State of California
AIR RESOURCES BOARD

Executive Order G-70-14-AA

Recertification of the Red Jacket Aspirator Assist
Phase II Vapor Recovery System

EXHIBIT 1

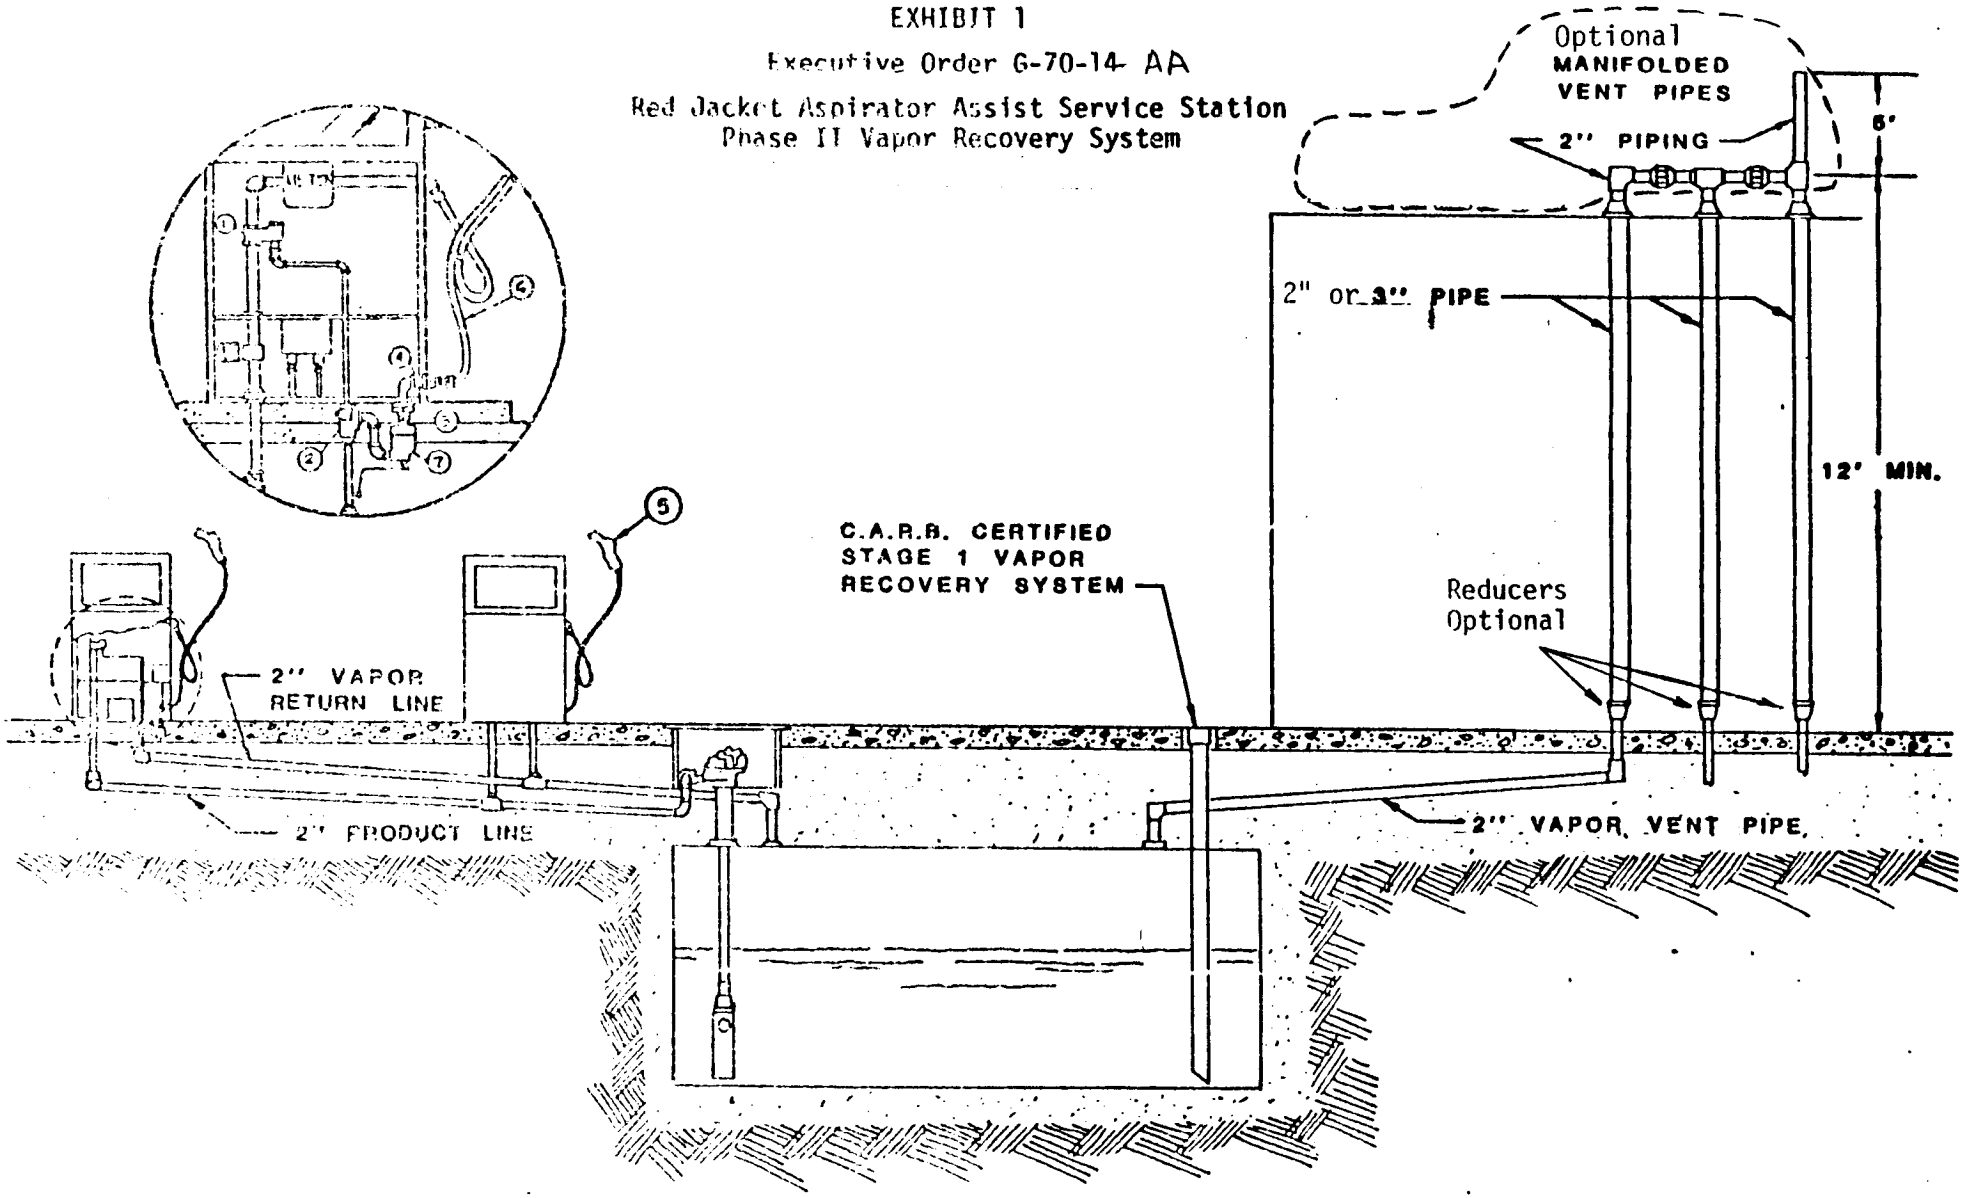
EXECUTIVE ORDER G-70-14-AA
NOTES TO ACCOMPANY EXHIBIT 1

1. For non-retail outlets which fuel special vehicles, the installation of vapor recovery hoses longer than specified in the latest version of Executive Order G-70-52 are allowed if the following conditions are met:

2. The vent pipes and vent manifold shall be adequately supported throughout their length and when they are supporting weights in addition to their own, additional supports may be required, such as anchoring to a building or other structure.

3. All vapor return and vent piping shall be equipped with swing joints at the base of the riser to each dispensing unit, at each tank connection, and at the base of the vent riser where it fastens to a building or other structure. When a swing joint is used in a riser containing a shear section, the riser must be rigidly supported.

4. Branch lines are required to be one inch or larger when connecting to a two-inch return pipe.

Uphill Eductor System Installation
(for vapor return lines with less than 1/8 inch per foot down slope from dispenser to product tank)

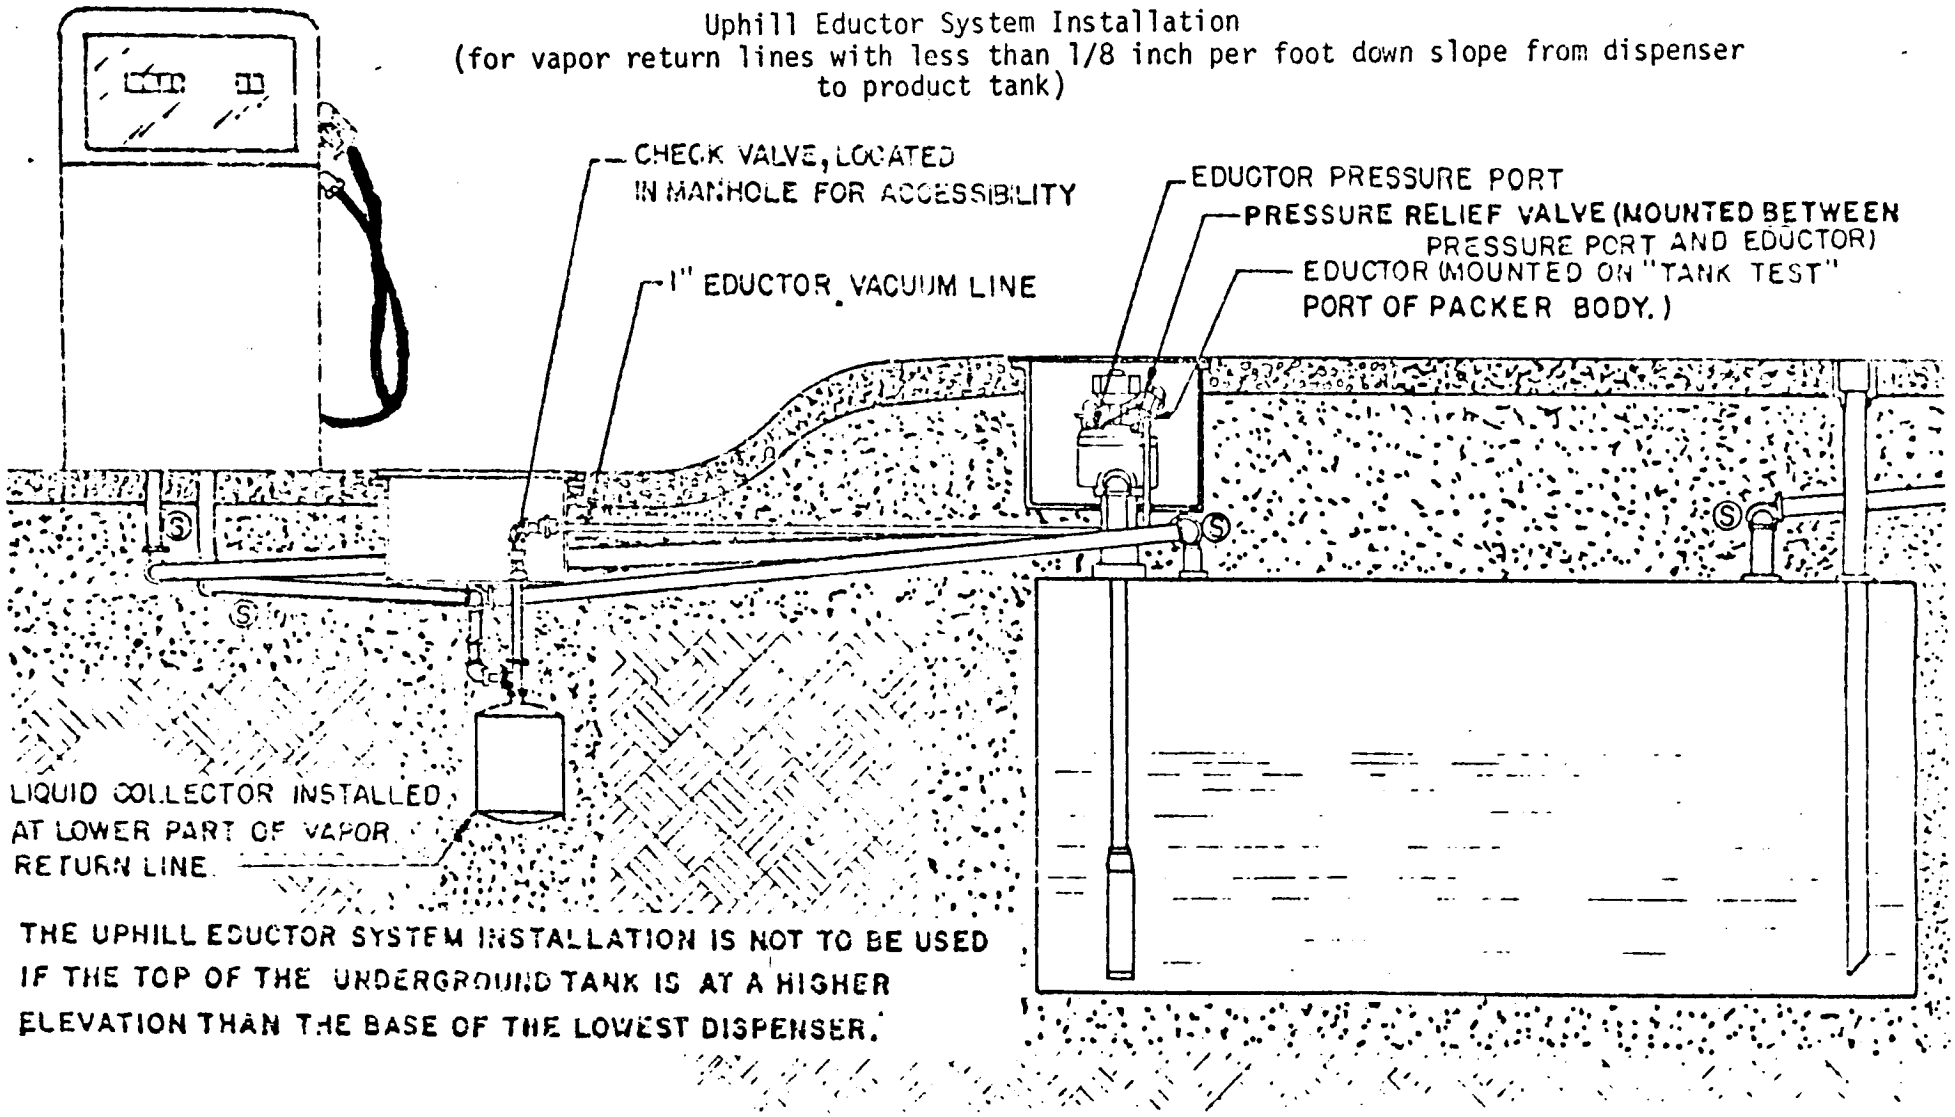
THE UPHILL EDUCTOR SYSTEM INSTALLATION IS NOT TO BE USED IF THE TOP OF THE UNDERGROUND TANK IS AT A HIGHER ELEVATION THAN THE BASE OF THE LOWEST DISPENSER.
